11/10/2021

SF2018/318466 | WST18/00146/07

**SSD-10419: consolidated mining lease (CML) 6, mining purposes lease (MPL) 854 and mining lease (ML) 1483 and ML 1805; Kidman Way (MR410), Cobar
New Cobar Complex Project**

Figure A 6: Basic right (BAR) turn treatment on a two-lane rural road

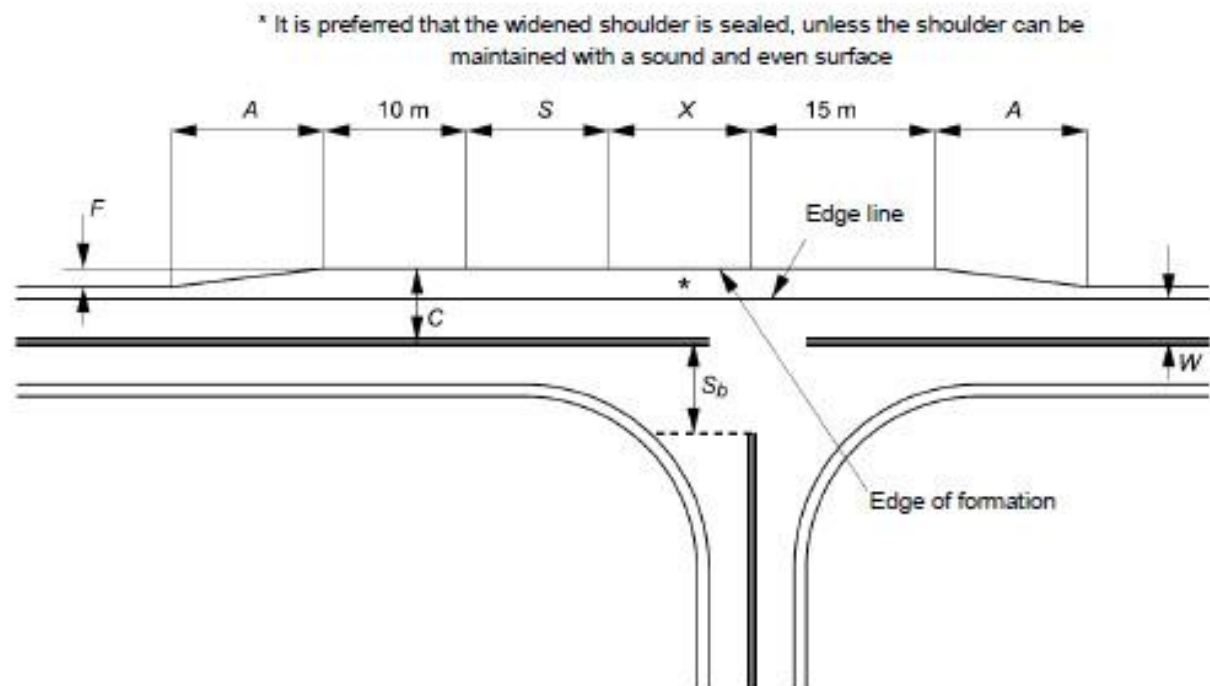
- A Rural Basic Right-Turn (BAR) Treatment (see Figure A6 of Part4 of AGTRD) is to be provided to accommodate 19m long turning design vehicle and the highway design vehicle length of 36.5m.

Figure 8.2: Rural basic left-turn treatment (BAL)

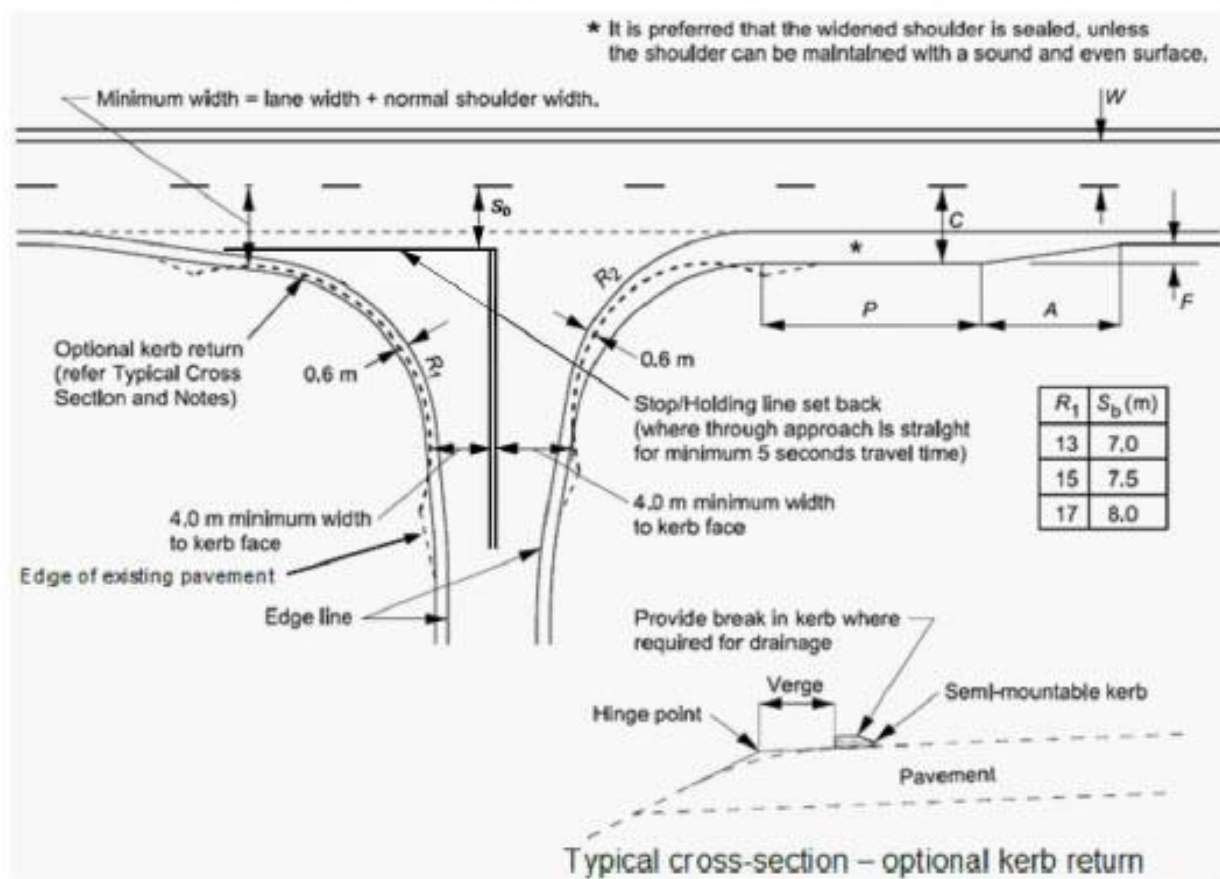
- Prior to the commencement of construction works, the intersection of the Kidman Way/Construction Access must be upgraded as follows:
 - A Rural Basic Left-Turn (BAL) Treatment (see Figure 8.2 of Part4A of AGTRD) is to be provided to accommodate 19m long design vehicle.

- A Rural Basic Left-Turn (BAL) Treatment (see Figure 8.2 of Part4A of AGTRD) is to be provided to accommodate 35.4m long design vehicle.
- Upgrade to accommodate the turning movements of a 35.4m B-Triple vehicle.
